## **PIERCE PINES SUBDIVISION**

APPLICATION NUMBER 4 DATE January 21, 2016

REQUEST Subdivision

# DETAIL SITE PLAN

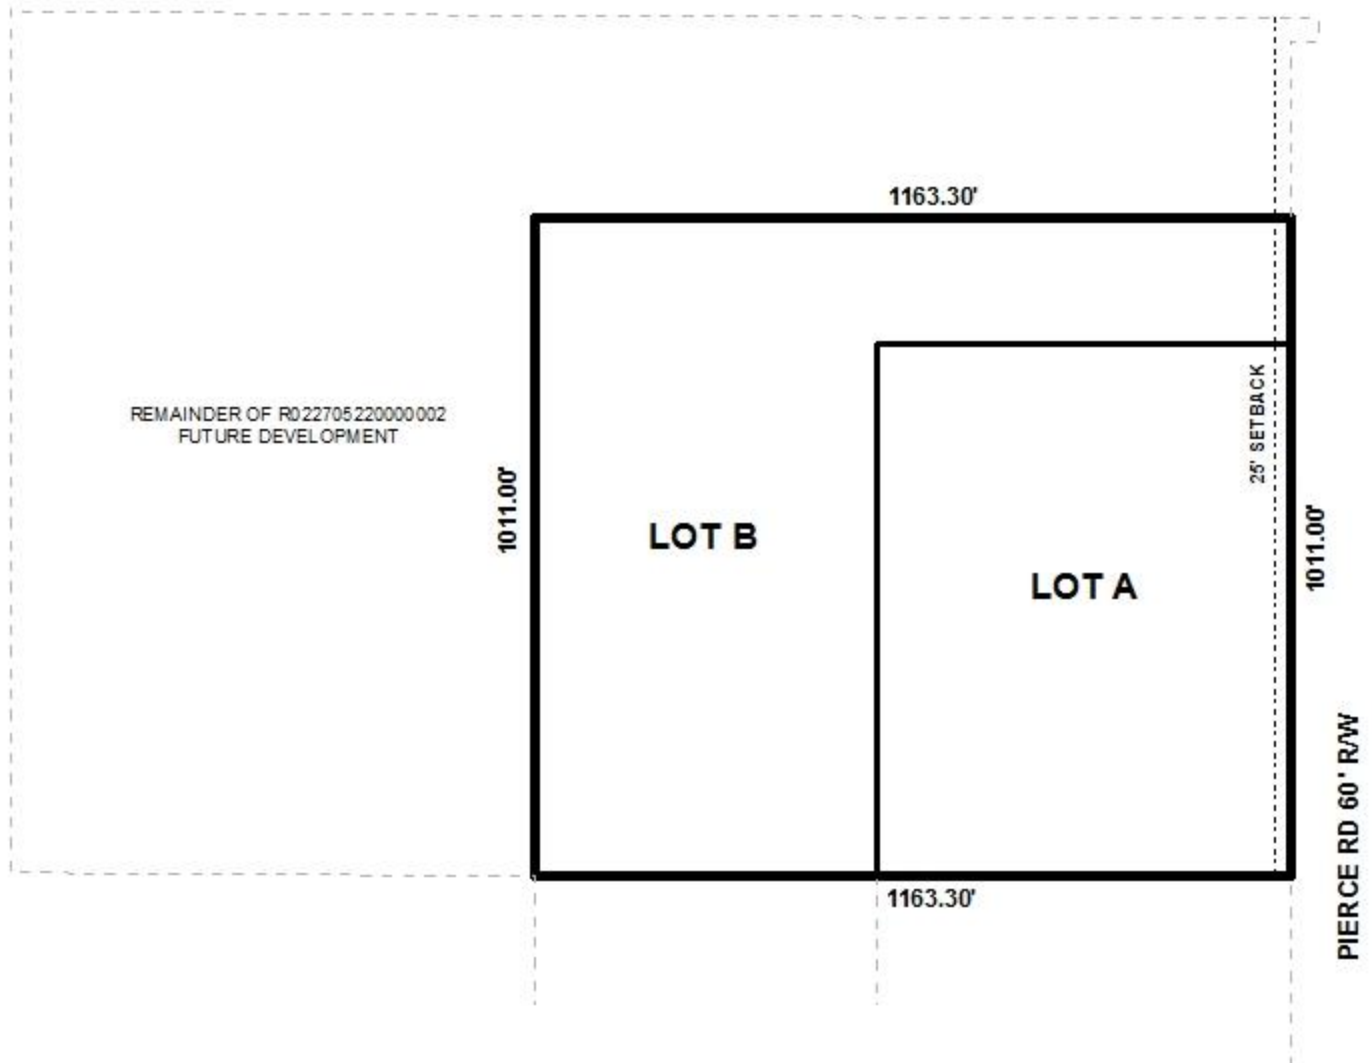
The proposed lot sizes are provided in acres, and each proposed lot exceeds the minimum required lot size in Section V.D.2. of the Subdivision Regulations. This information should be provided on the Final Plat in square feet and acres, if approved.

The subdivision has frontage on Pierce Road, a minor road with no curbs or gutters thus requiring a 60' right-of-way. The existing right-of-way depicted for the proposed subdivision is 60'; therefore no dedication should be required. Additionally, as a means of access management, a note should be placed on the final plat stating that the Lot A should be limited to two curb cuts to Pierce Road, and that Lot B is limited to one curb cut, with the size, location, and design to be approved by County Engineering and in conformance with AASHTO standards.

It should be noted that the proposed Lot B is a flag lot with a 192' wide, 638' long “pole”. There are no other flag lots in the area, nor was any justification provided by the applicant as to why the proposed subdivision cannot comply with Section V.D.1. of the Subdivision Regulations. However, since the “pole” width of 192' is so substantial, a waiver V.D.1. may be appropriate if future subdivision is not allowed. Furthermore, the proposed Lot B also exceeds the width-to-depth ratio in V.D.3. of the Subdivision Regulations, being 192' wide at the building setback and 1,163' deep. There are several lots in the area which also exceed the width-to-depth ratio, making a waiver of Section V.D.3. of the Subdivision Regulations appropriate.

The 25-foot minimum building setback is illustrated on the preliminary plat. If approved, this information should be retained on the Final Plat.

Based upon the preceding, the application is recommended for Tentative Approval, with a waiver of Sections V.D.1. and V.D.3. of the Subdivision Regulations, subject to the following conditions:

- 1) placement of a note on the Final Plat stating the lot sizes in square feet and acres on the Final Plat, or the furnishing of a table on the Final Plat providing the same information;

- 2) placement of a note on the Final Plat stating that no future subdivision of Lot B will be allowed due to the flag lot reconfiguration;
- 3) placement of a note on the Final Plat stating that Lot A is limited to two curb cuts to Pierce Road, and that Lot B is limited to one curb cut, with the size, location and design to be approved by Mobile County Engineering and conform to AASHTO standards;

- 4) retention of the 25' minimum building setback line along Pierce Road;
- 5) placement of a note on the Final Plat stating that any lots which are developed commercially and adjoin residentially developed property must provide a buffer, in compliance with Section V.A.8. of the Subdivision Regulations;
